# City of Albuquerque

REF: REVISED TEMPORARY DRAINAGE PLAN FOR LOVELACE CLINIC PARKING LOT  
(L18-D29) ENGINEER'S STAMP DATED JULY 1, 1985

Based on the information provided on your September 4, 1985 resubmittal, the above referenced drainage plan is approved for grading permit.

GRADING AND DRAINAGE PLAN  
OF  
LOVELACE CLINIC PARKING LOTS  
THE NORTHWEST HALF OF BLOCK 26  
VIRGINIA PLACE ADDITION  
ALBUQUERQUE, NEW MEXICO  
APRIL 1985

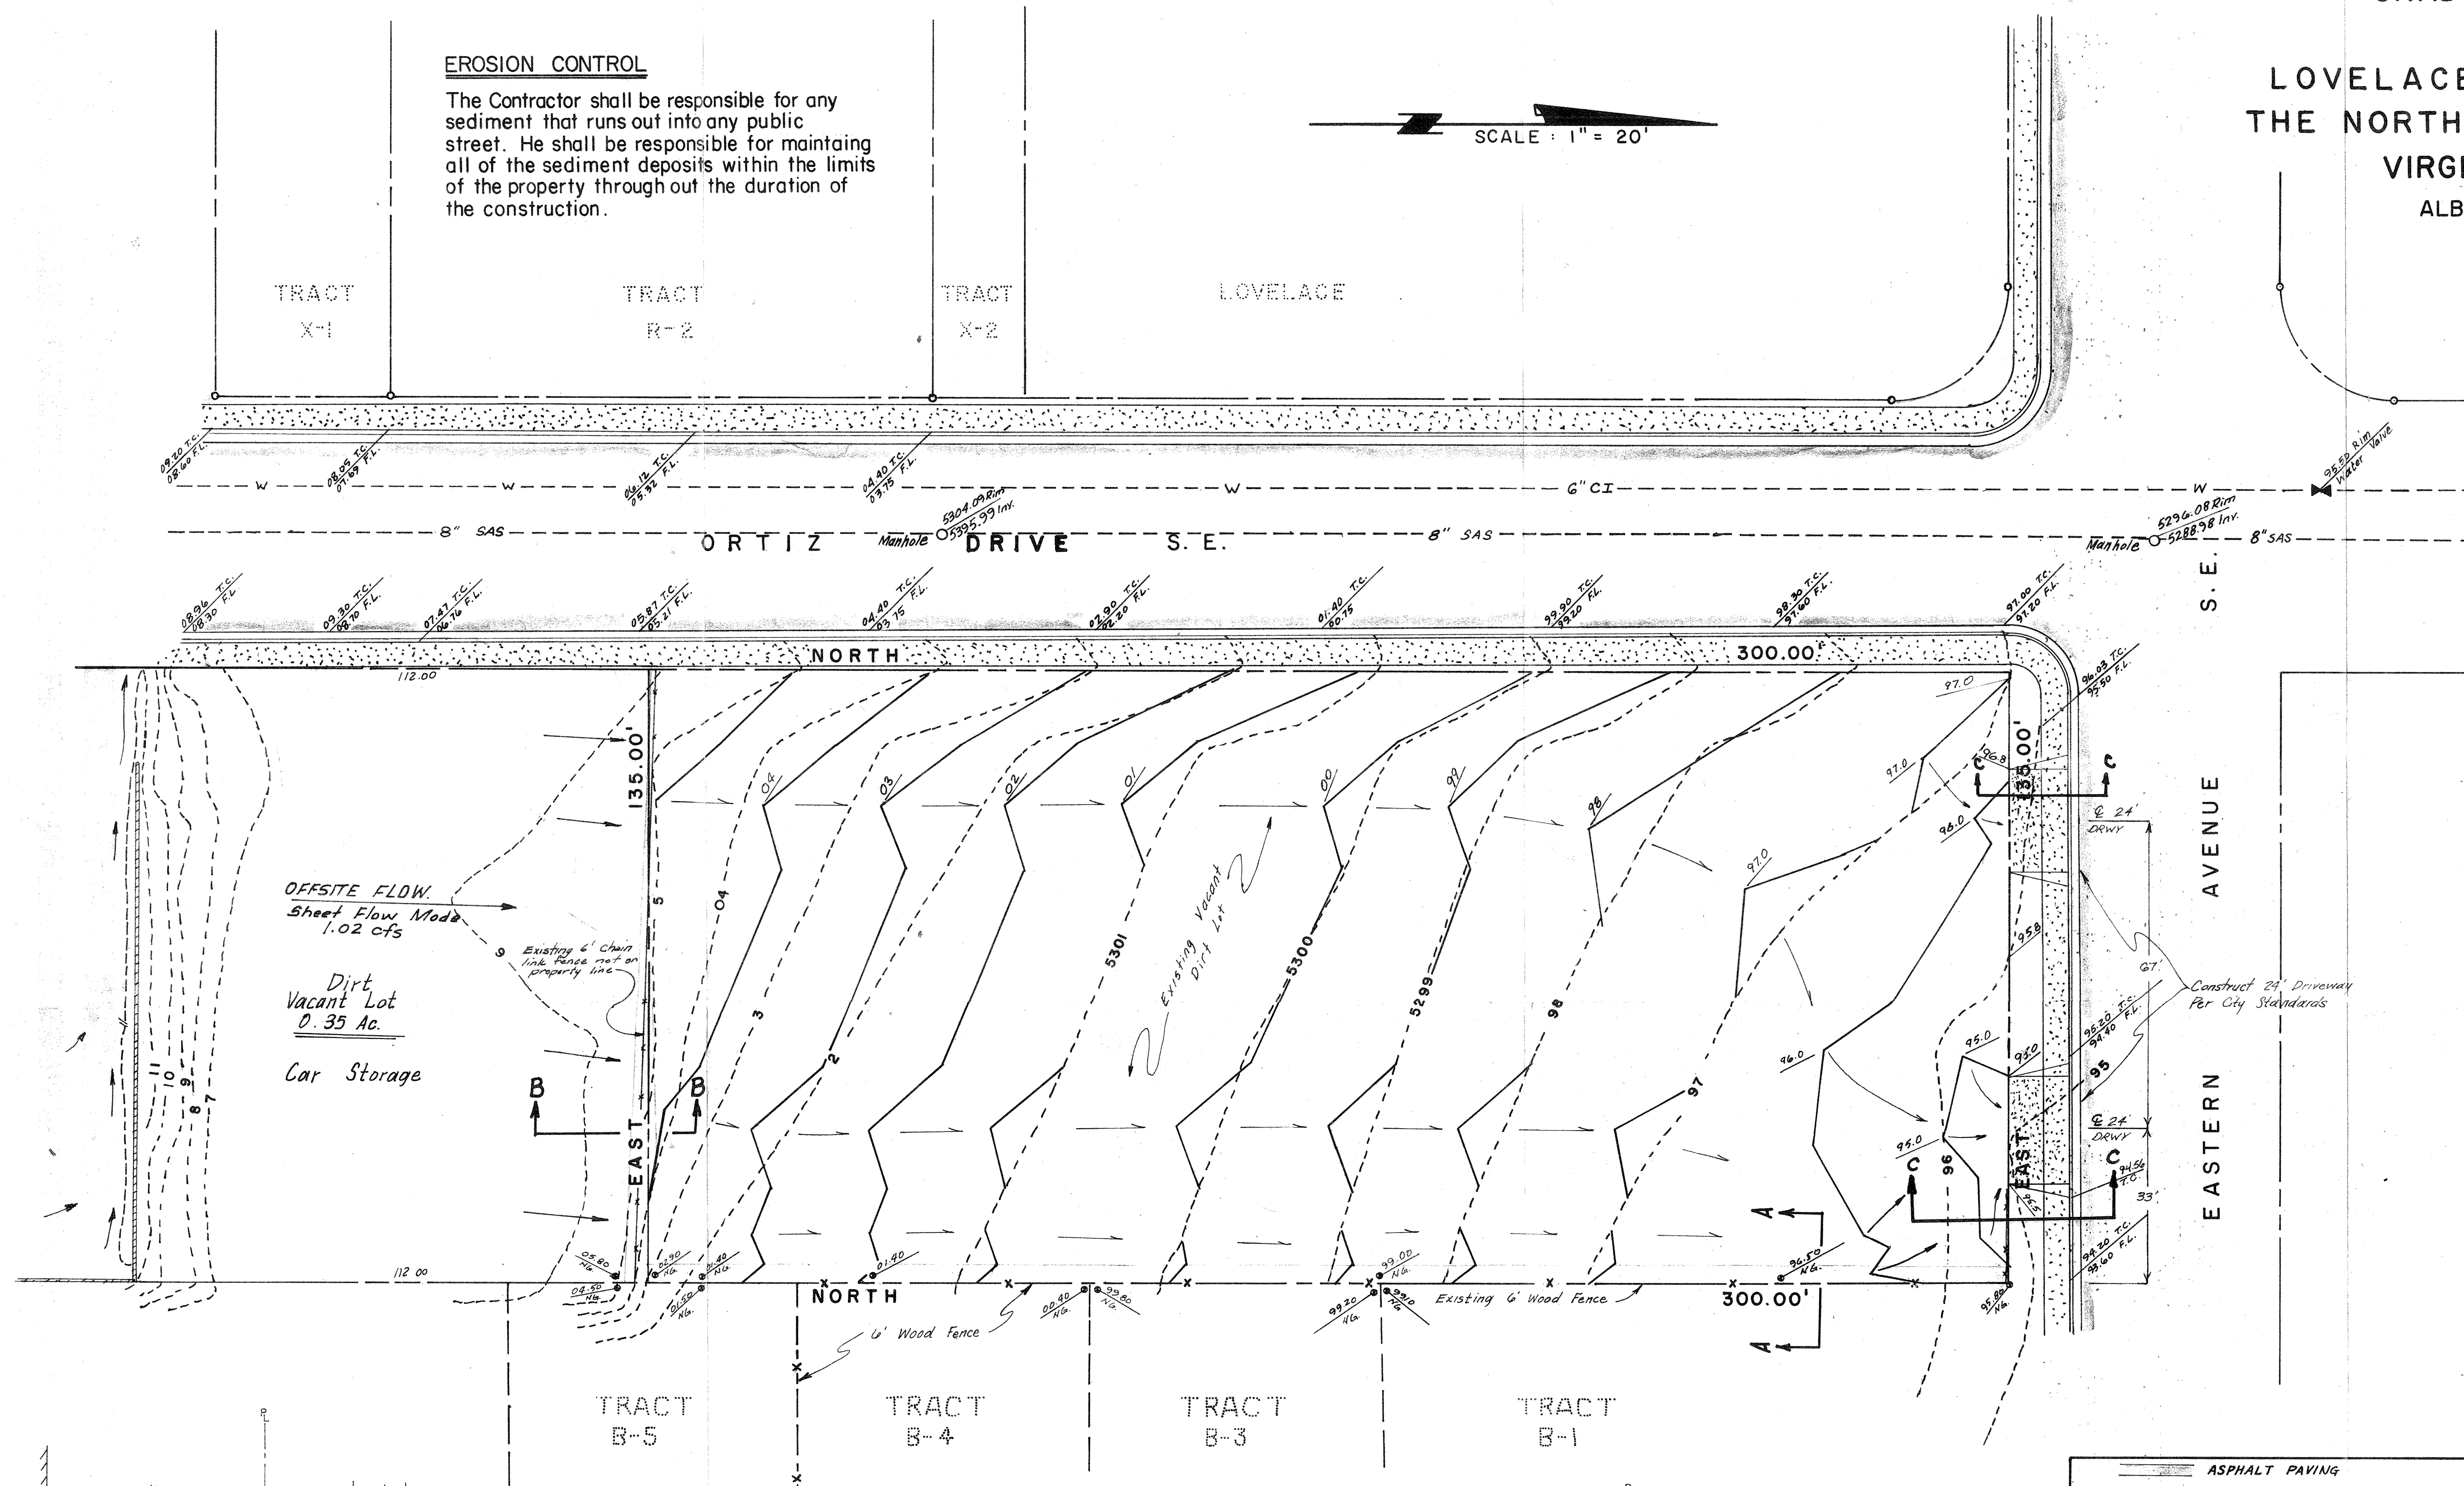
Please advise your client that a compaction report will be required for the proposed berm on the east property line when completed. Also, no runoff will be allowed over the public sidewalk adjacent to Eastern Avenue SE.
